**SUBJECT: ACCC – LOADING DOCK REMEDIATION PHASE II – ADDENDUM #1**

**ATLANTIC CITY CONVENTION CENTER**  
**LOADING DOCK TRENCH DRAIN REPLACEMENT AND RELATED WORK**  
**ADDENDUM #1**  
**JULY 31, 2024**

# CITY OF ATLANTIC CITY ATLANTIC CITY CONVENTION HALL LOADING DOCK PHASE II TRENCH DRAIN REPLACEMENT

SHEET TITLE:  
KEY PLAN  
DRAWING LIST

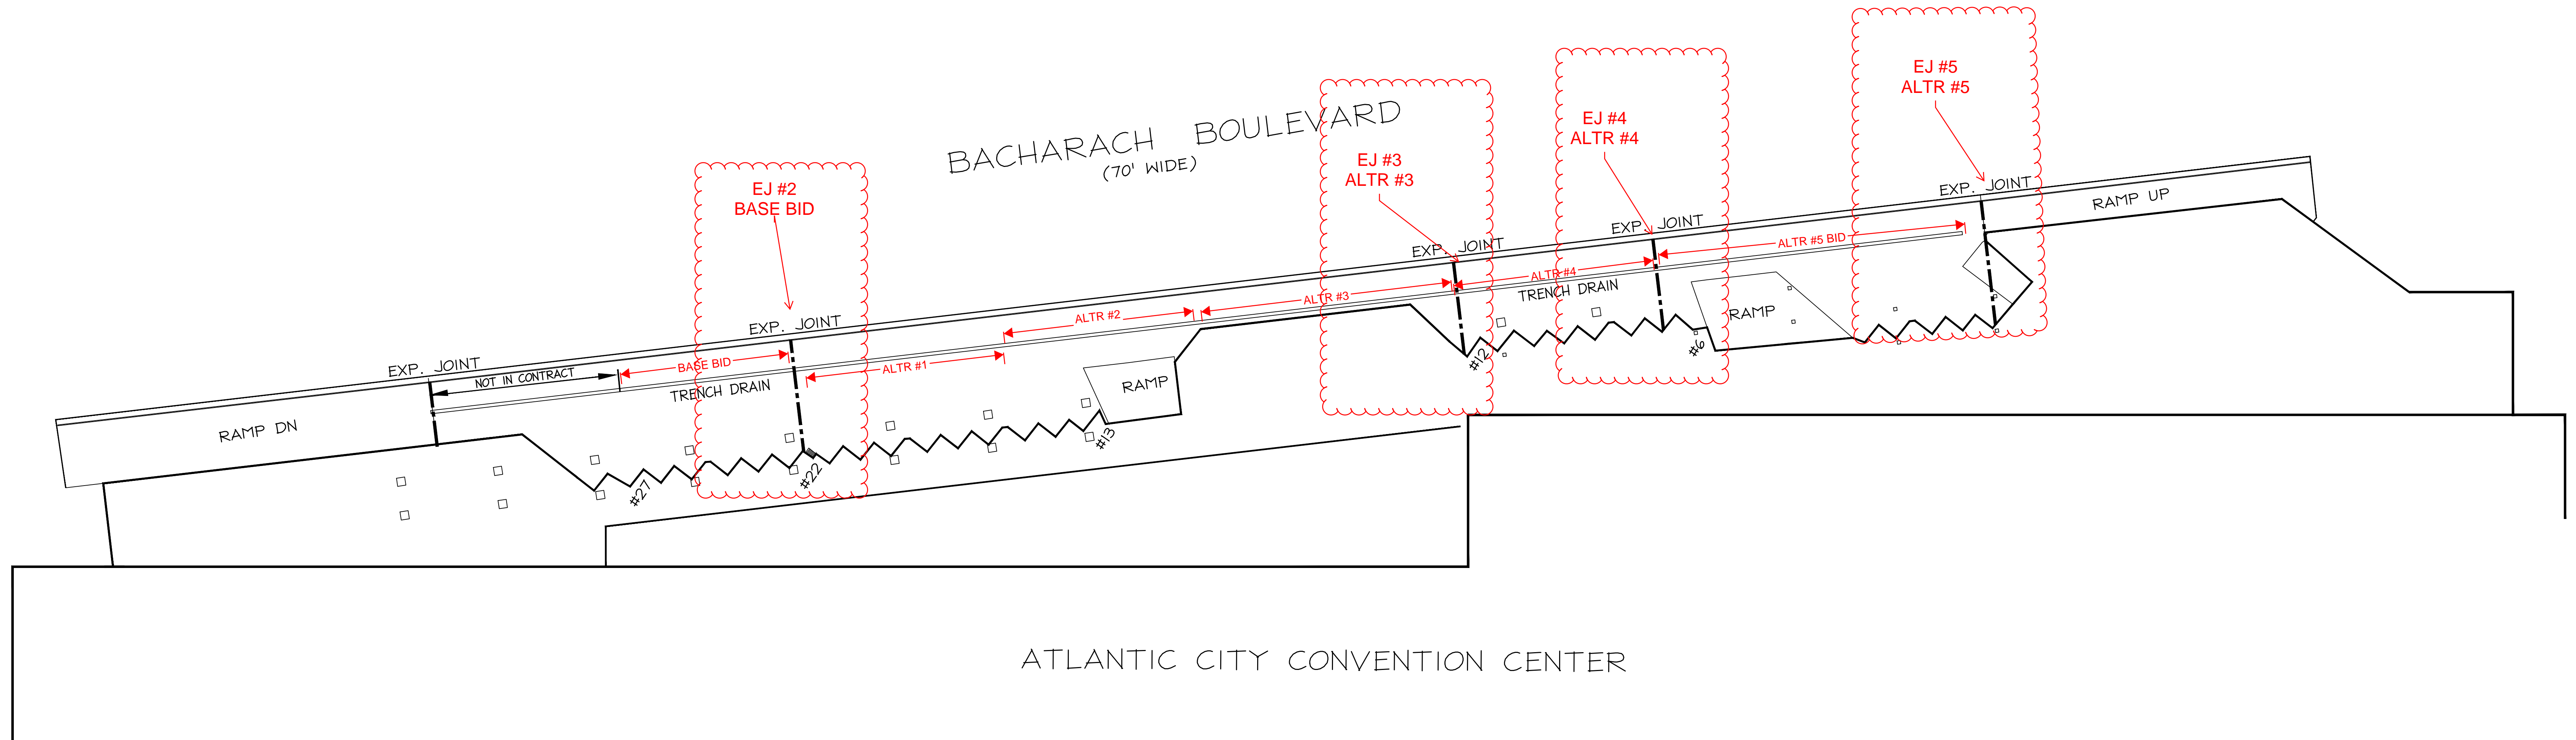
3. The key plan drawing "C" outlines the area of the trench drain that is in the base bid and identifies each trench drain alternate but does not explain where the cost of each expansion joint is to be captured, (ex: base bid, which alternate, etc). Please clarify. **SEE ATTACHED EJ BID CLARIFICATION DATED 07-31-24**

4. The key plan drawing "C" shows area of the base bid and alternates 1 thru 5 but does not match the alternate notes (ex: bid #1) on drawing S-1 & S-2, please confirm drawing "C" takes precedence. **USE DRAWING "C" FOR BID AND ALTERNATE LOCATIONS**

ADDENDUM #1  
EJ LOCATION CLARIFICATION  
07-31-24
